ARKANSAS POWER & LIGHT COMPANY

January 31, 1985

SUBJECT: Arkansas Nuclear One - Unit 1
Docket No. 50-313
License No. DPR-51
ANO-1 Inservice Inspection Program Response
to Request for Additional Information

ATTACHMENT TO 1CAN018507

FIG. IWB-2500-14 SUPPORT CIRCUMFERENTIAL WELD JOINT

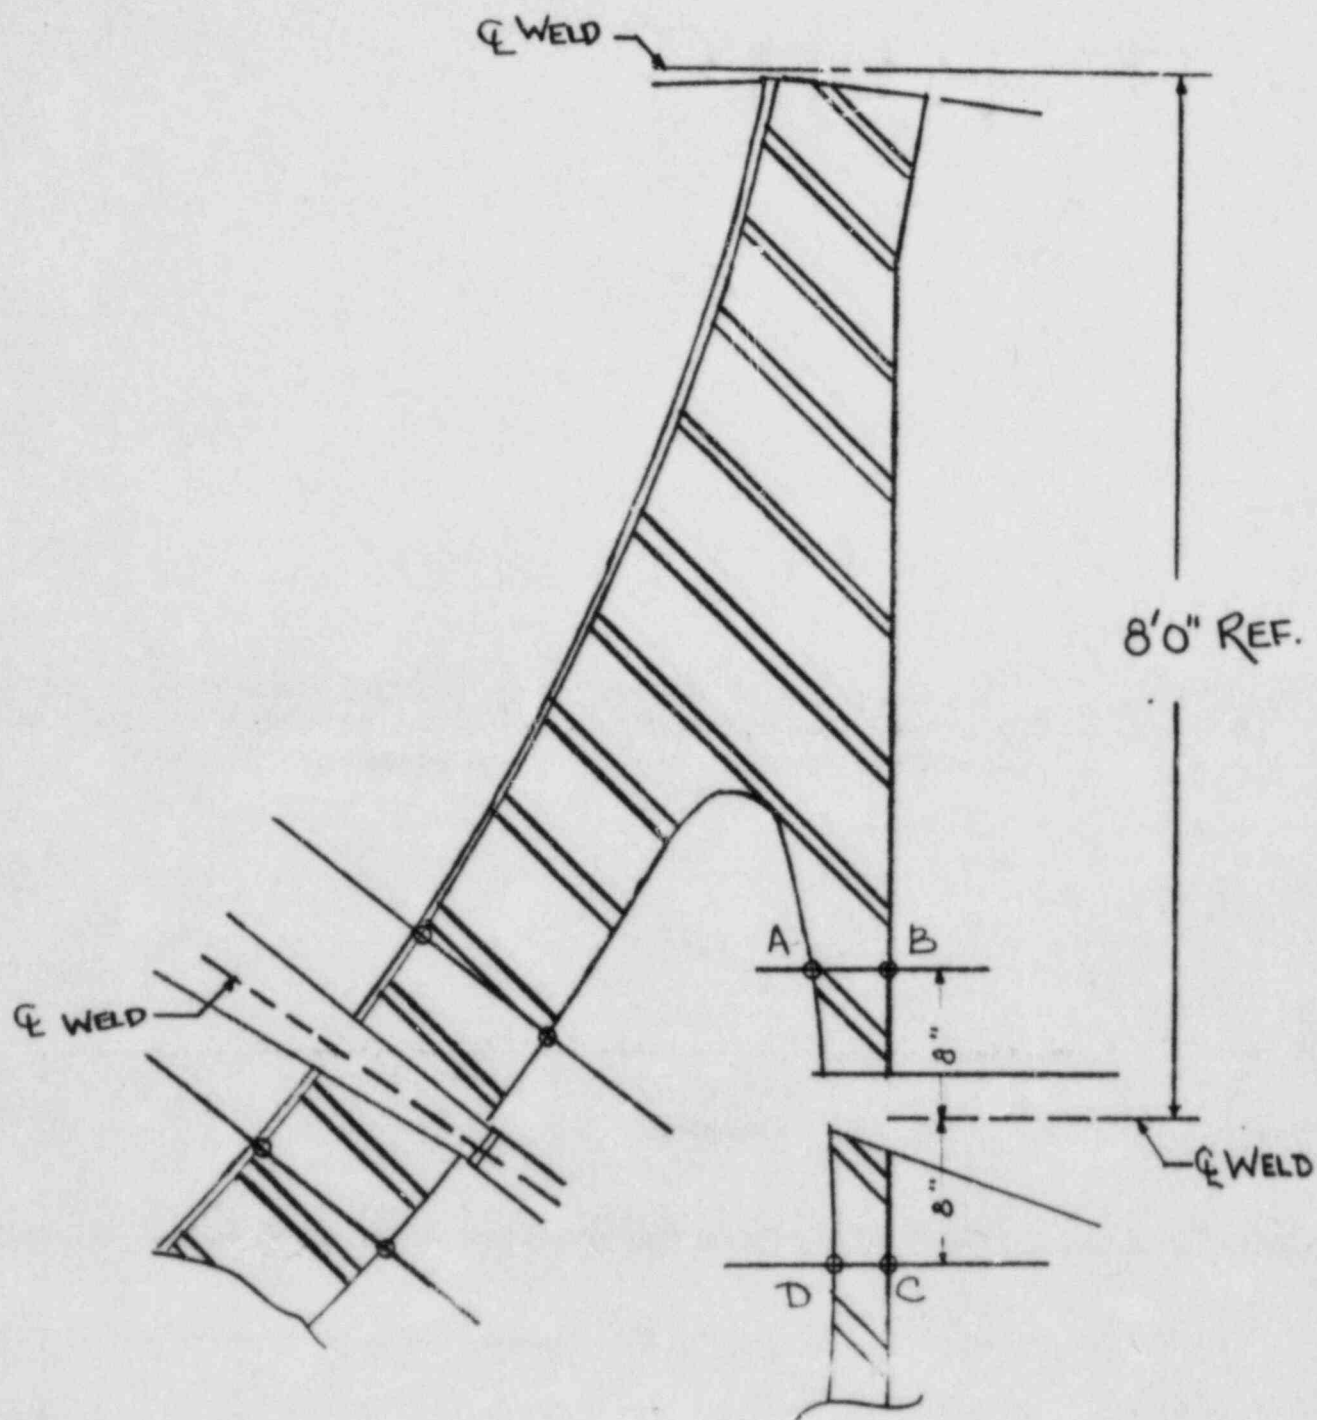
- "2. The second relief request on page 2 of Reference 1 concerns NDE of the reactor vessel support skirt-to-vessel weld. Figure 1 of the reference showing a section of this structure is unclear, and the labeling is not readable. Please supply a copy of this drawing that clearly shows the dimensions of interest."

This drawing has been redrawn with emphasis on the welds. A copy of the revised drawing is enclosed as requested.
